No. EC155-25-154

SERVICE BULLETIN

EQUIPMENT AND FURNISHINGS - Electrical hoist
One time verification for no damage on cable hook side and preventive actions

76378-25-13

Figure 1: Cable diameter restriction located at edge of bottom cup of the hook assembly

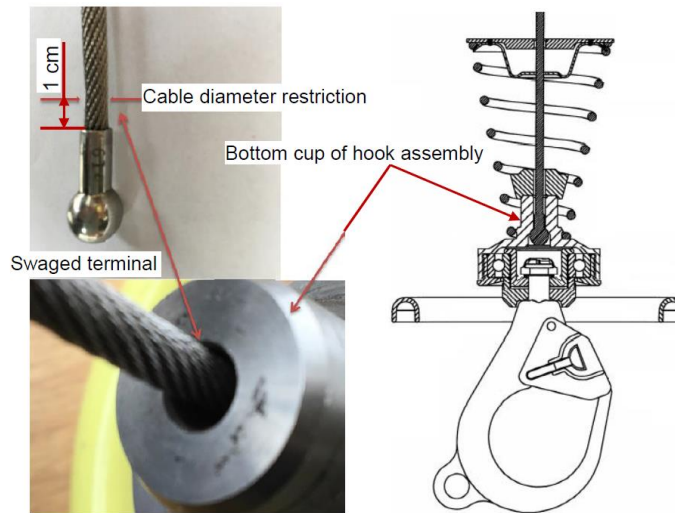
Customers reported cases of cable diameter restriction, found at the edge of the bottom cup of the hook assembly. The cable diameter restriction was found at about 1 cm from the swaged terminal. This restriction with interactions between the cable and the bottom cup of the hook assembly (back and forth motion) could cause damage during flights.

Figure 1: Cable diameter restriction located at edge of bottom cup of the hook assembly.

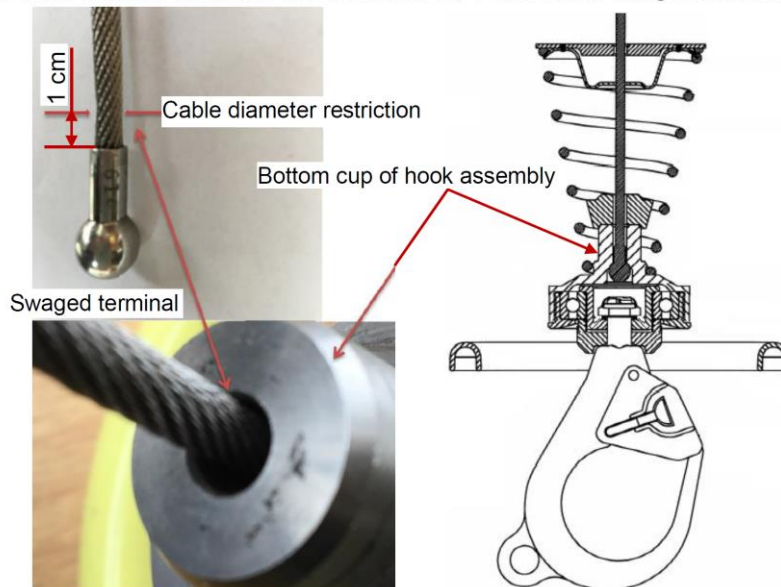
The cable diameter restriction was located about 1 cm from the swaged terminal.

- (2) Improper hook assembly stowage combined with interactions between the cable and the bottom cup of the hook assembly (back and forth motion) could induce such damages during flights.

Figure 2

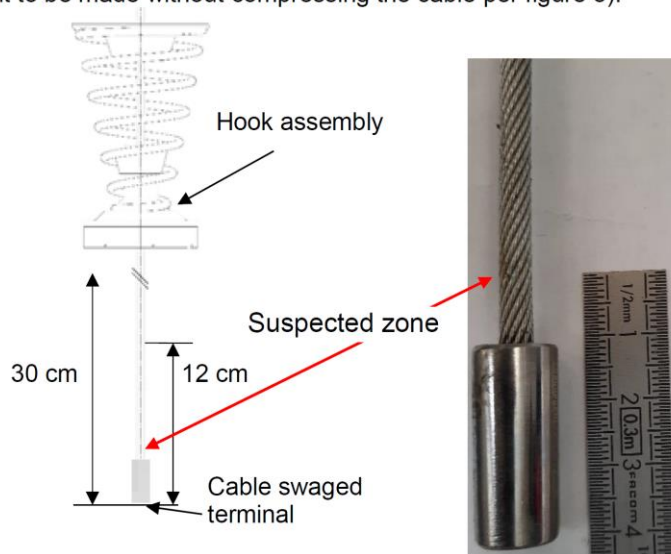
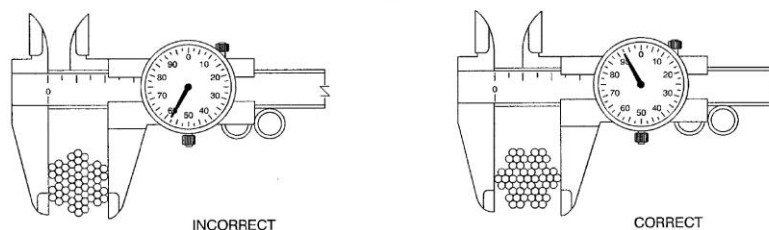
- A. One time verification for no damage on cable hook side as cable diameter restriction near swaged terminal
- (1) Apply power to the hoist system and unwind 2 to 3 meters (6.5 to 10 ft) of cable.
 - (2) Turn off power to the hoist system.
 - (3) Remove the bottom part of the hook assembly in accordance with para 7.A.(1) of chapter REPAIR of CMM.
 - (4) Disengage and lift up the upper part of the hook assembly on about 30 cm in order to observe properly the cable near swaged terminal (see figure 2).
 - (5) Clean and wash the cable near swaged terminal as required.
 - (6) Verify the cable condition on at least 12 cm length from the cable swaged terminal (see figure 2)

Check for cable damages as written in para 4.D.(2) and 4.D.(3) of chapter CHECK of the CMM. Verify especially if there is a cable diameter restriction at about 1 cm from the cable swaged terminal - cable minimum diameter must be ≥ 4.50 mm (0.181 in) (measurement to be made without compressing the cable per figure 3).

Figure 4: Proper stowage of hook assembly at the Up Limit stop

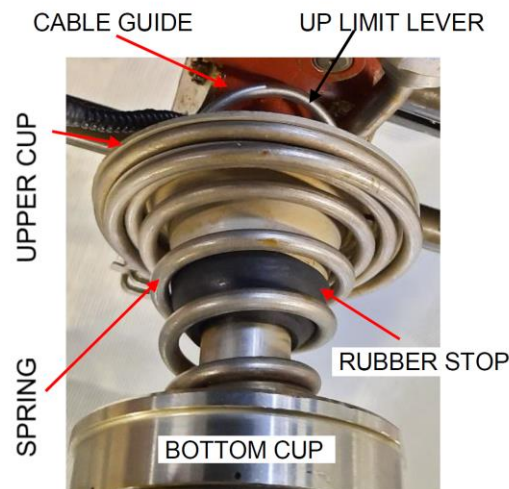
CAUTION: WHEN THE HOISTING MISSION IS FINISHED, HOOK ASSEMBLY MUST BE PLACED, WITHOUT LOAD HANGED ON HOOK, AT THE UP-LIMIT STOWAGE POSITION. IF THIS INSTRUCTION IS NOT RESPECTED, THIS WOULD INDUCE PREMATURE CABLE DAMAGES DURING FLIGHTS.

After a first cable reeling-in stop (when upper cup of the hook assembly activates the up limit lever) continue to activate control pendant fully in the up direction. After two seconds (2 s) the cable reeling-in starts again at very low speed. Reel in command at maximum order on the control pendant shall be maintained until cable reeling in completely stops.

Make sure hook assembly is steadily pressed onto the cable-guide as shown on figure 4.

- Proper compression of the spring;
- Bottom cup, rubber and upper cup are steadily pressed together on cable-guide.
